Department of Planning and Zoning

14-0720CA; 180-188 Battery Street

Request: Amend ZP#10-0601CA/MA for change to north facade (King Street) for pedestrian

entry and new vent.

(d) Provide an active and inviting street edge

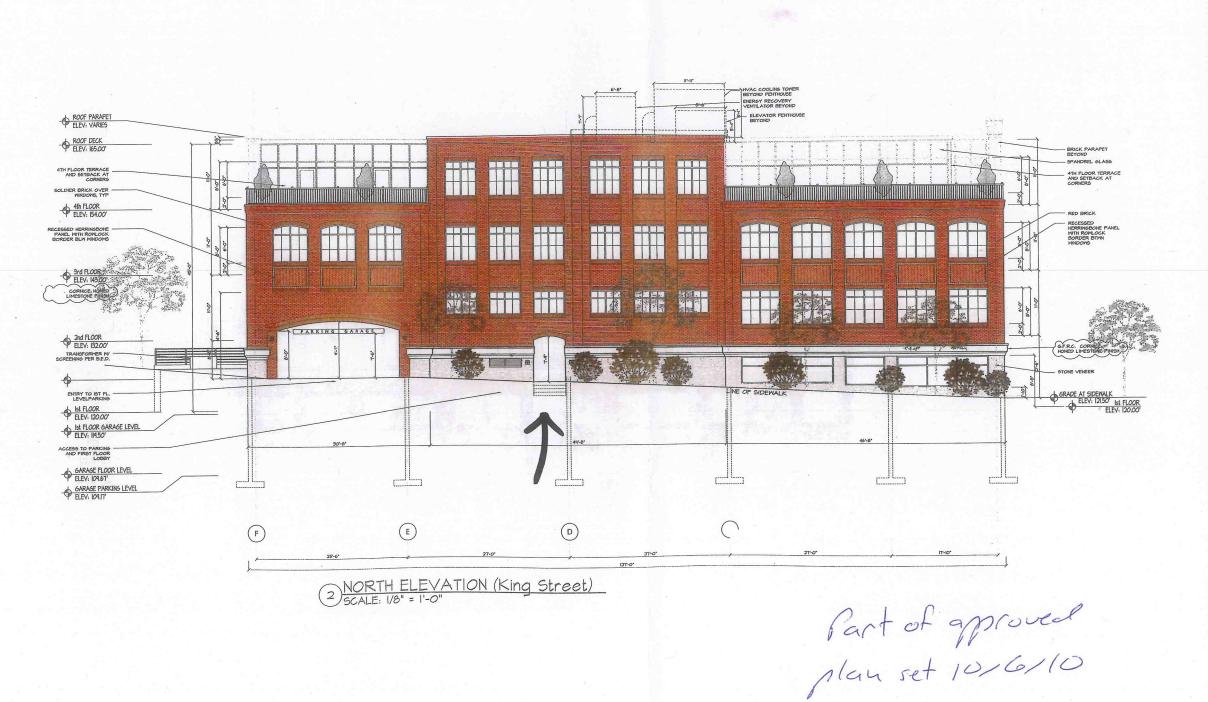
The applicant is seeking approval of as-built changes to the King Street façade of the recently completed office building at 180-188 Battery Street (zoning permit 10-0601CA/MA). Specifically, the applicant is requesting approval to gate off and effectively eliminate the pedestrian entrance facing King Street. There is also a change to the approved building vents adjacent to the eliminated pedestrian entrance. Rather than two smaller rectangular vents, there is now one larger square vent.

The building as constructed largely reflects the approved project plans and is a marked improvement over the previous site conditions. The vent change noted above is relatively minor and acceptable. The proposed elimination of the King Street pedestrian entrance is not. As reflected in the two staff reports, associated DRB meeting minutes, and final DRB decision, this pedestrian entrance was part of the applicant's response to DRB and public comment to liven up the King Street façade and to effectively render it a second primary façade. The outside appearance of the pedestrian entry is as approved; however, it was not constructed as a functional entry, and the applicant wishes to close it off with a gate. Doing so would eliminate a key component in making this building's King Street façade inviting and pedestrian friendly. Rather than gate it off, the entry should be made functional as approved. (Adverse finding)
